Sent: 14/05/2021 2:27:58 PM
Subject: 750-752 Pittwater Road Objection Letter from LOT 11 Plush Locksmiths | DA2021/0388
Attachments: 750-752_Pittwater Rd_Objection _ 14.05.2021.pdf; HUMEL Marked Up Site Plan_14.05.2021.pdf; HUMEL Marked Up Floor Plan_14.05.2021.pdf;

**RE: OBJECTION LETTER FROM LOT 11 PLUSH LOCKSMITHS TO DA2021/0388 –
ALTERATIONS & ADDITIONS TO AN EXISTING COMMERCIAL PREMISES INCLUDING
SIGNAGE AT SHOPS 1 TO 13 INCLUSIVE AND SHOPS 15 & 16, 750-752 PITTWATER
RD, BROOKVALE**

Photograph No:1 **Original open landscaped area and open stair access to Lot 11.**
Lot 11 visible from the street footpath & signage from Pittwater Road.

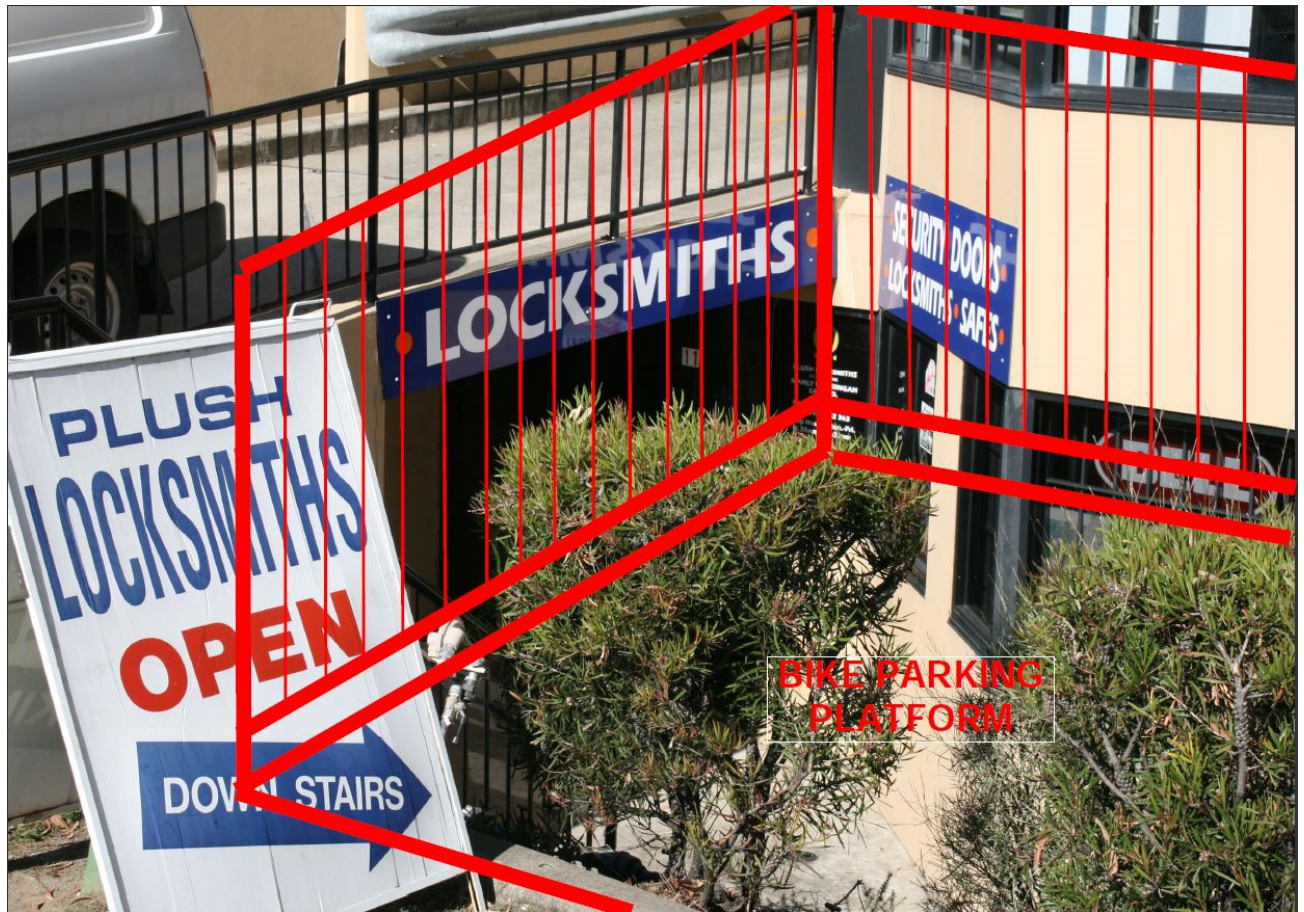
- The location of the bicycle platform negatively impacts the lower level area at the entry to Lot 11 by providing physical structures over a metre higher than the existing footpath level plus a collection of bicycle obstructions at an average of 1200mm height and handrails with vertical barriers at over 3.0 metres above the Lot 11 Plush Locksmiths shop entrance level, refer photographs 1 and 1A below.

- Effectively Lot 11 and its signage will be obscured from Pittwater Road and light, air and amenity will be unacceptably reduced at the lower level entrance, refer photographs 1 and 1A below.

Photo No:1A Mark-up showing proposed bicycle platform and railings adjacent the Lot 11 entry stair.

Lot 11 not visible from the street footpath and signage not visible from Pittwater Road

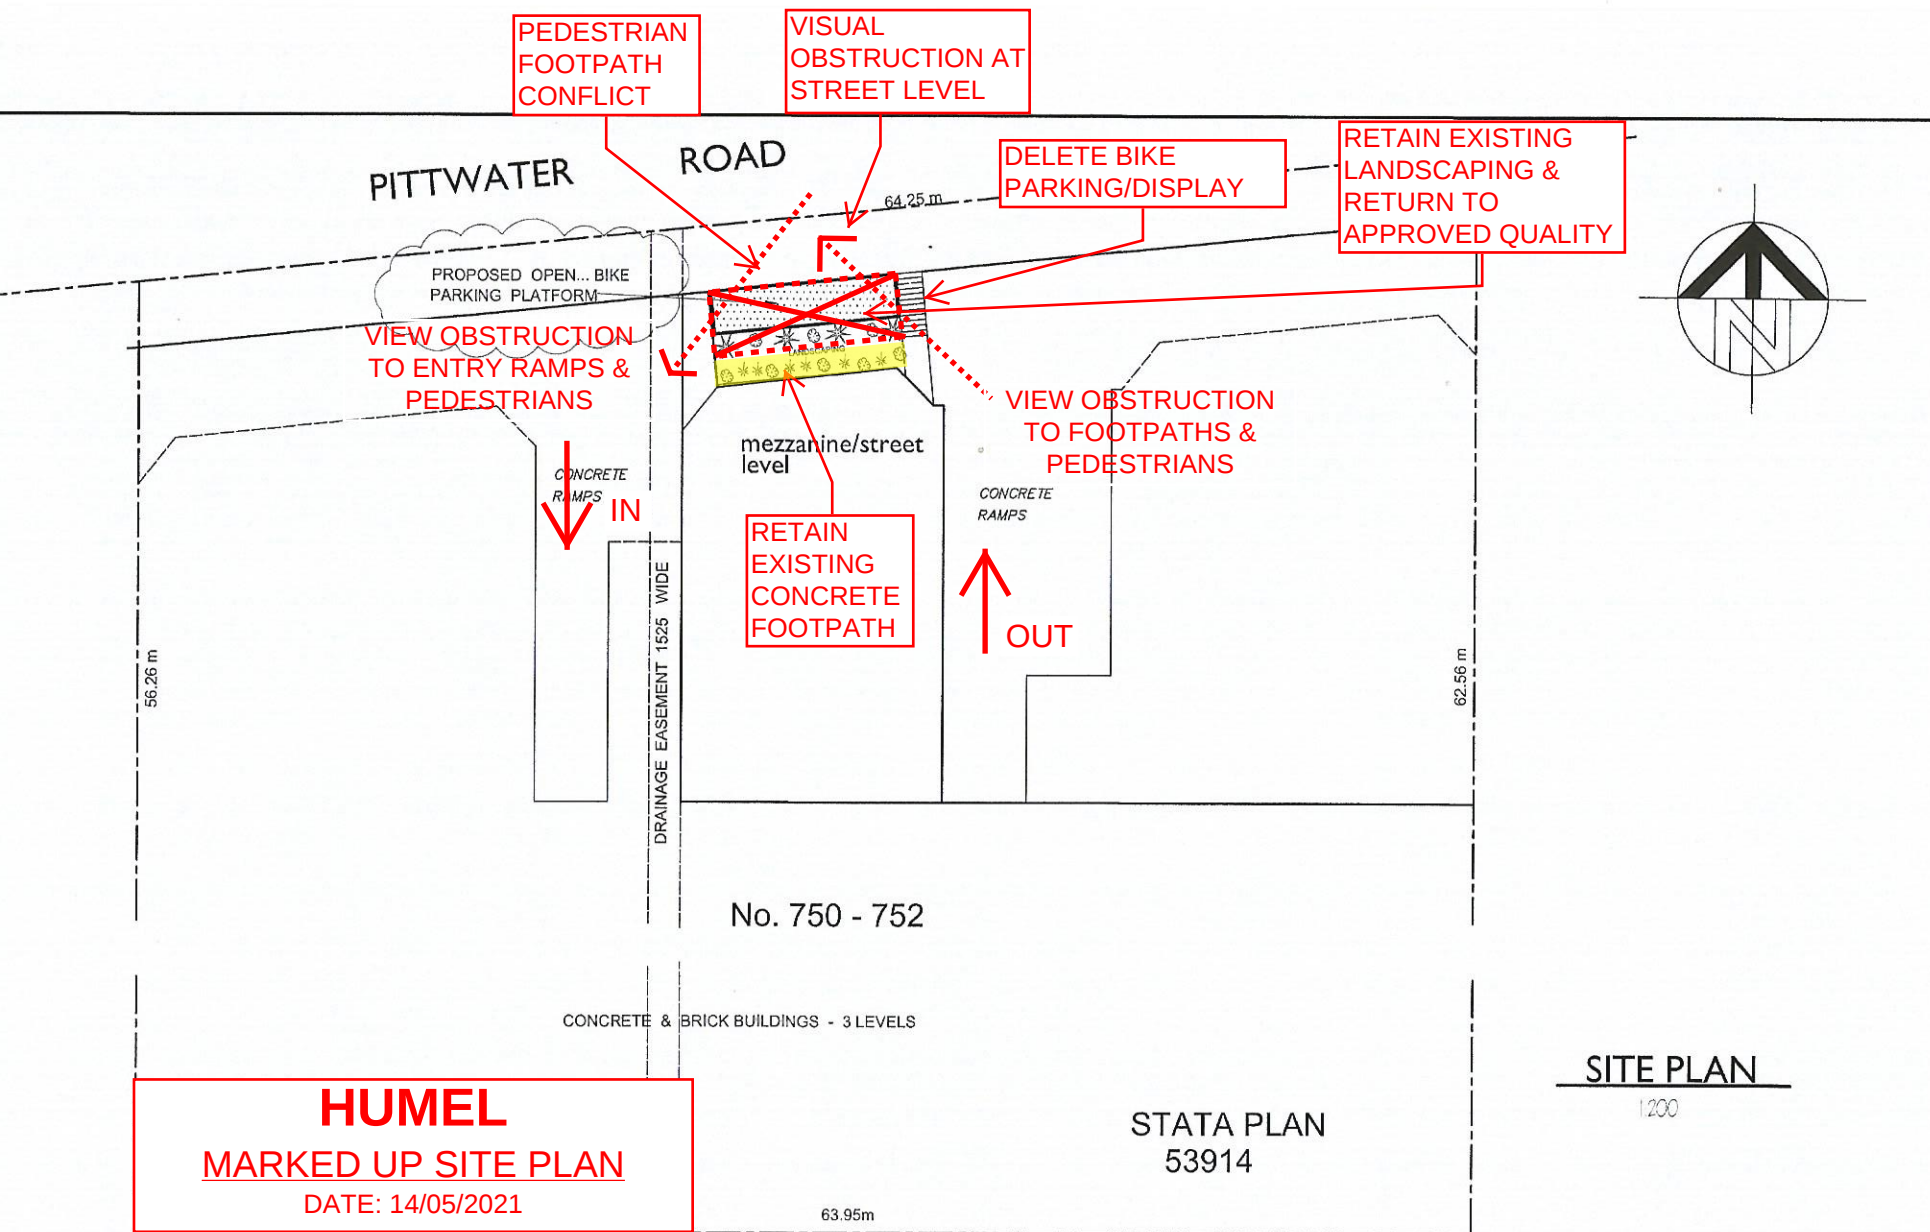
Refer attached Humel marked up plan No's: DA.2013/11 and DA.2013/12D dated 14.05.2021.

- 3.1 Delete the proposed bicycle parking and display area adjacent Pittwater Road, refer attached Humel marked up plans.
- 3.2 Retain approved landscape in the original location and re-establish the plants in the approved landscape design including significant tree planting.
- 3.3 Maintain a sense of openness and setbacks consistent with WDCP 2011, clause B7 Front Boundary Setbacks.

Dwg. No: **2013/12D** Date: APRIL '20
Scale: 1:100
SHEET 2 OF 3

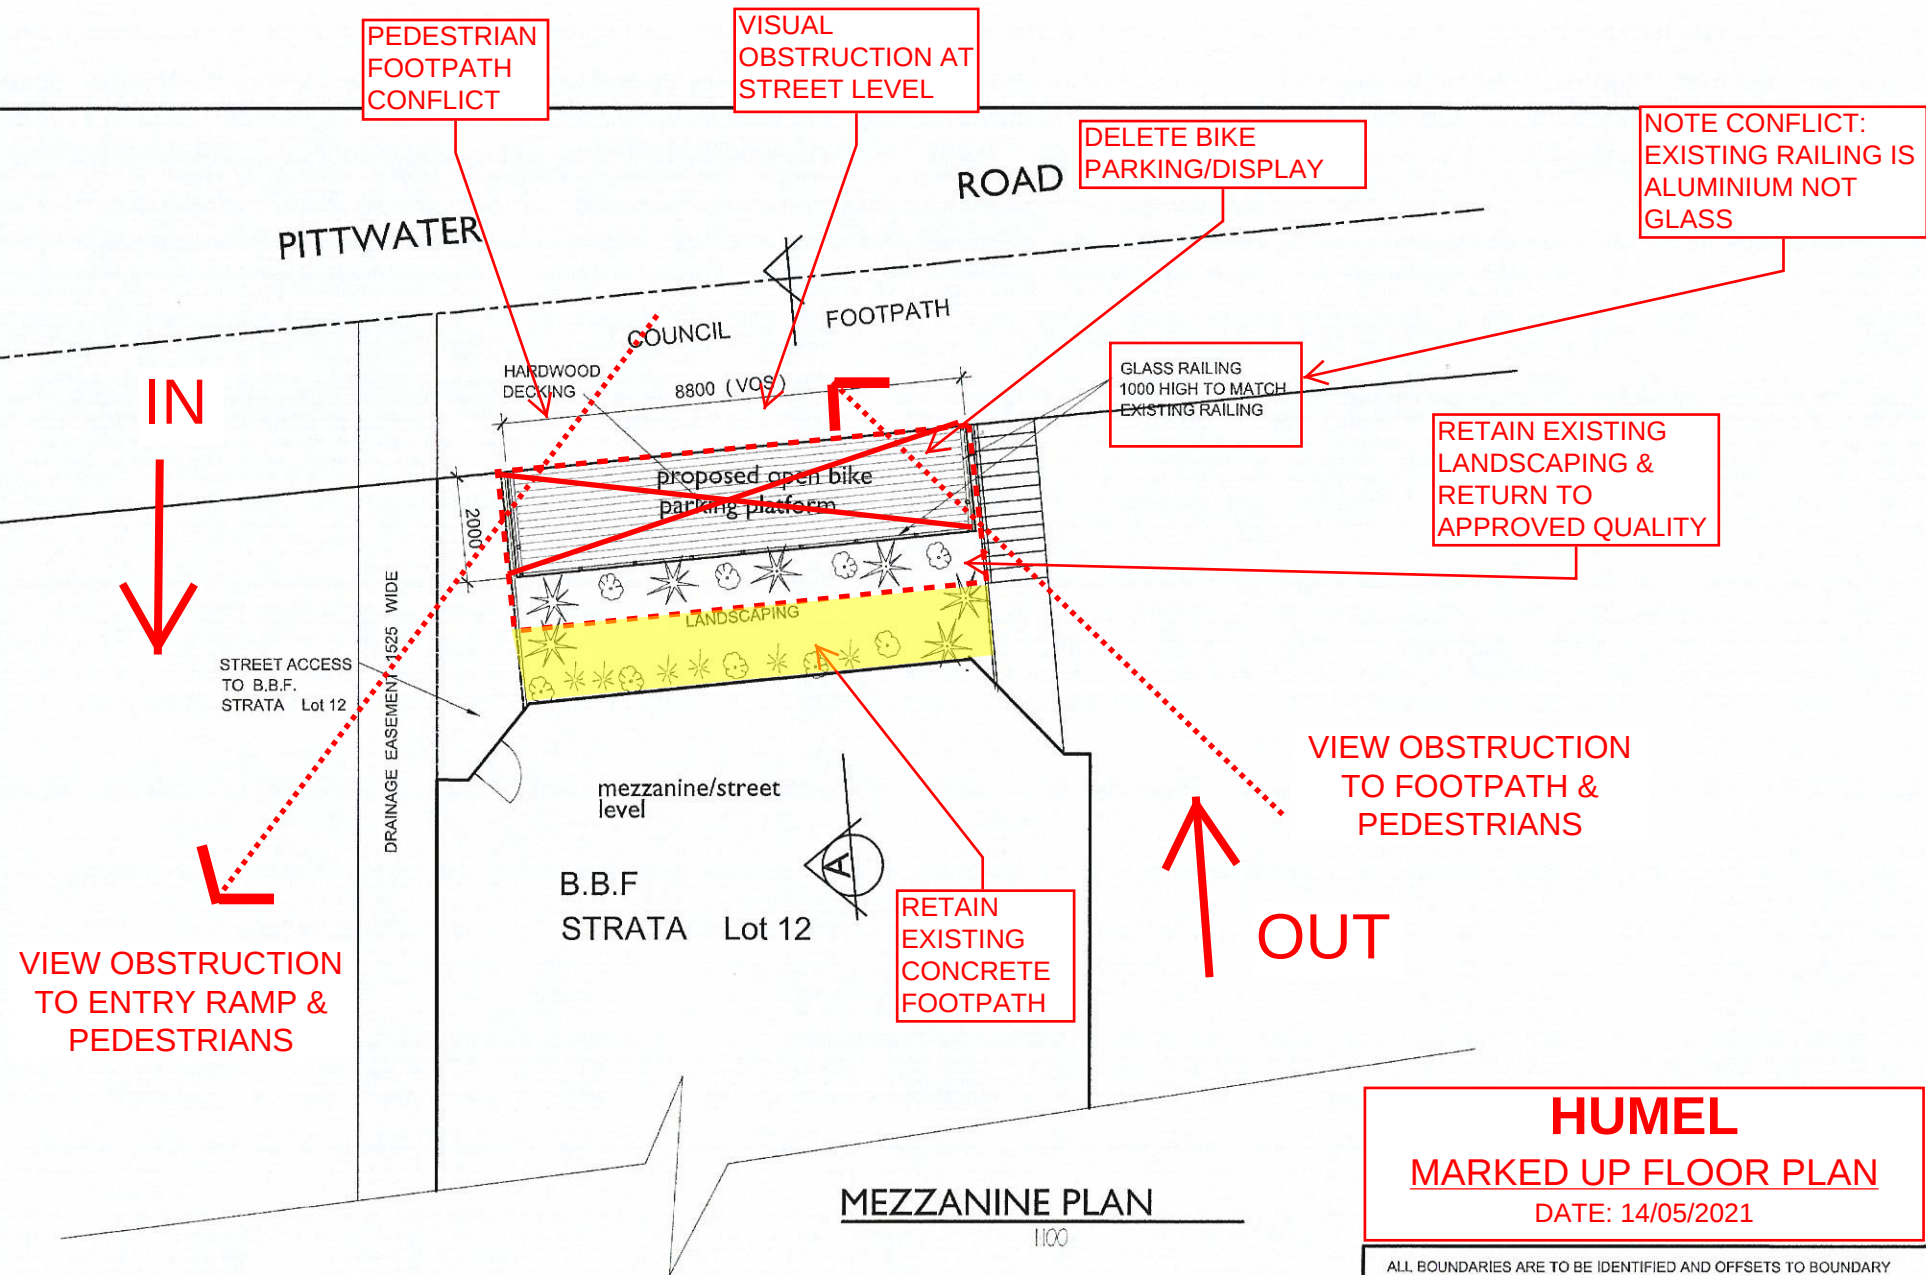
Refer attached Humel marked up plan No's: DA.2013/11 and DA.2013/12D dated 14.05.2021.
